Agenda – East Kildonan-Transcona Community Committee – November 17, 2015

Item No. 8 Plan Approval – 65 and 85 Fiorentino Street (Transcona Ward) File DAV 155010/2015C

Title: Plan Approval, 65 and 85 Fiorentino Street
Critical Path: East Kildonan – Transcona Community Committee

Figure 2: Proposed Site Plan and Recommended Changes **North↑**

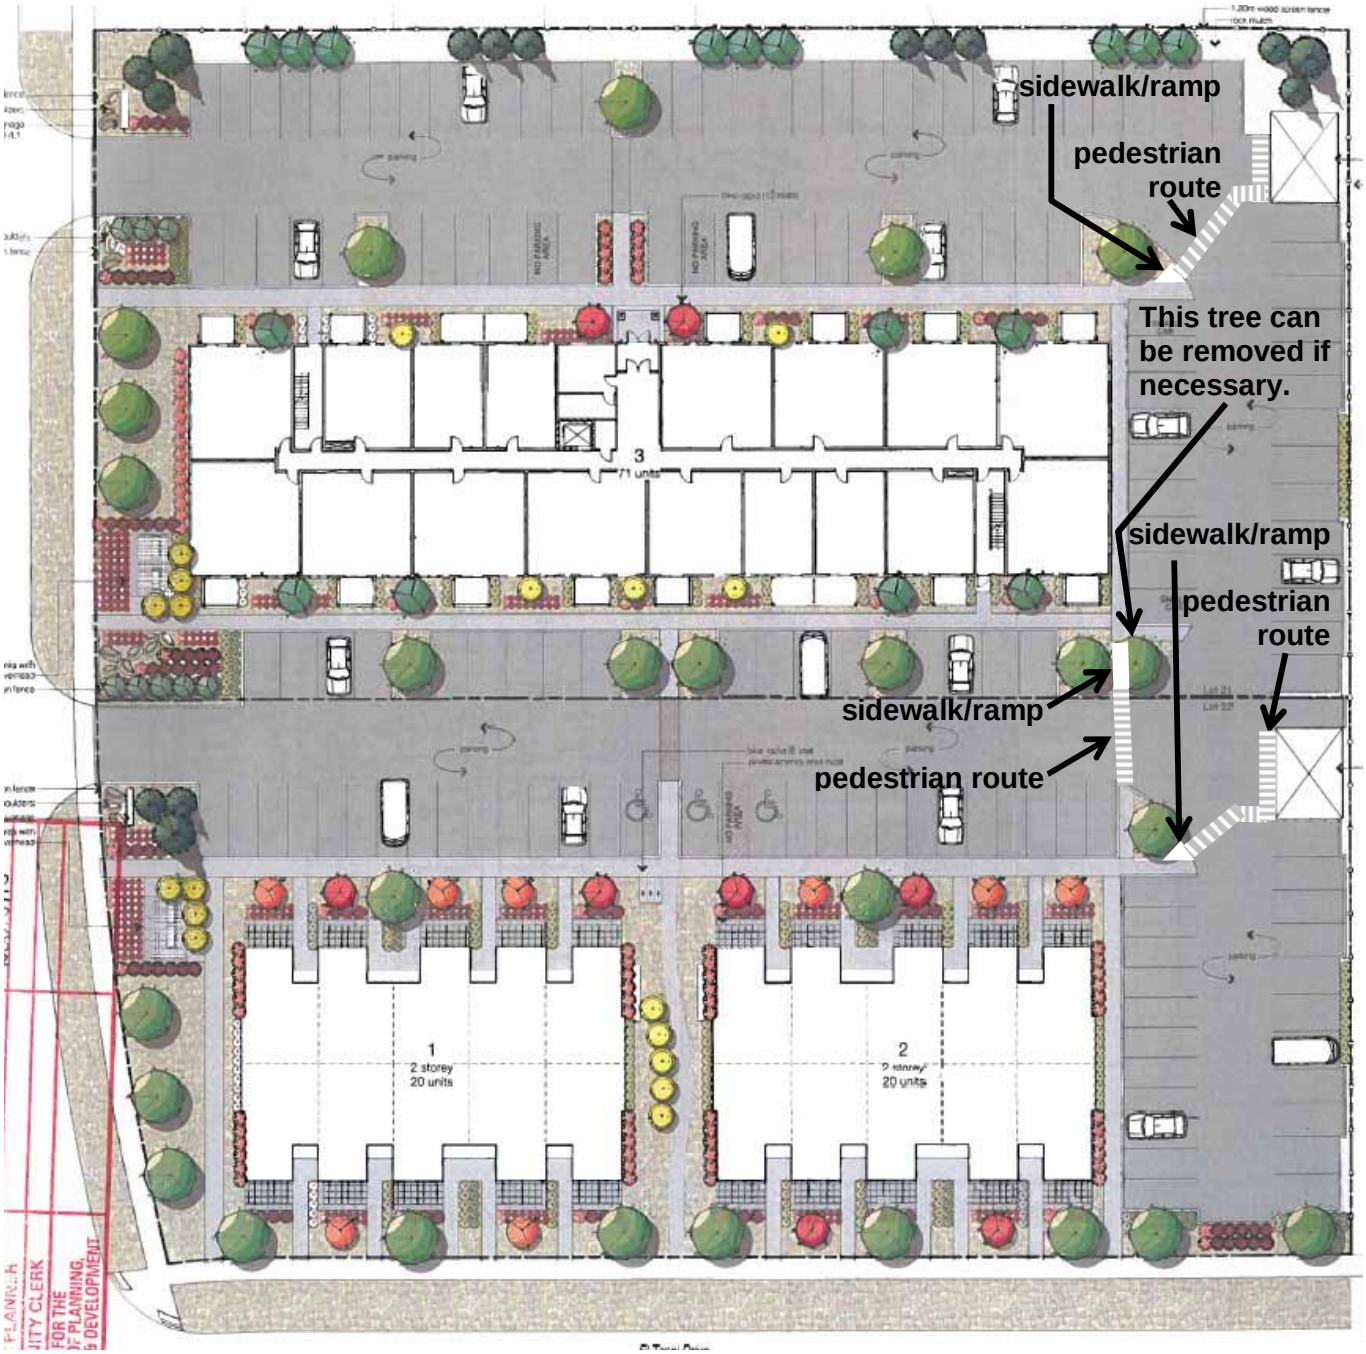
- that the proposed development would enhance the quality of the pedestrian environment of El Tassi Drive and Fiorentino Street because
  - the proposed residential buildings would be close to these public streets and
  - half the units in the proposed townhouses would be facing El Tassi Drive;
- that on-site pedestrian routes provide direct routes from the main building entrances and *most* ground floor dwelling units to off-site destinations; and
- that pedestrian routes to the garbage and recycling enclosures are not provided.

The *Transcona West Area Structure Plan* states, in Section 5.4.2(3), that Residential Mixed-Use Areas "shall contain… a well-defined pedestrian-oriented component that emphasizes… "internal pedestrian routes to buildings and amenities…" If the submitted plans are amended as recommended by the Urban Planning Division, they would be consistent with this policy.

The Urban Planning Division recommends approval of the submitted plans as amended by the Urban Planning Division and shown on Figure 2. The amendments are:

- to connect the sidewalks along the east sides of the proposed apartment style building and the proposed easterly townhouse to one another by showing, on the landscaping/site plans, sidewalks/ramps extending to the parking aisle north of the proposed townhouses and a pedestrian crossing of that parking aisle;
- to connect the proposed sidewalks to the proposed garbage and recycling enclosures by showing, on the landscaping/site plans, sidewalks/ramps extending northeasterly to the nearest drive aisles and adding pedestrian routes to, and along the front of, the enclosures; and
- if necessary to implement the first amendment, by removing, from the landscaping/site plans, the most southeasterly proposed tree on Lot 21.

The first amendment stated above would result in a more direct route for many residents heading toward Peguis Street via El Tassi Drive. The second amendment would clearly identify pedestrian routes to the garbage enclosures.
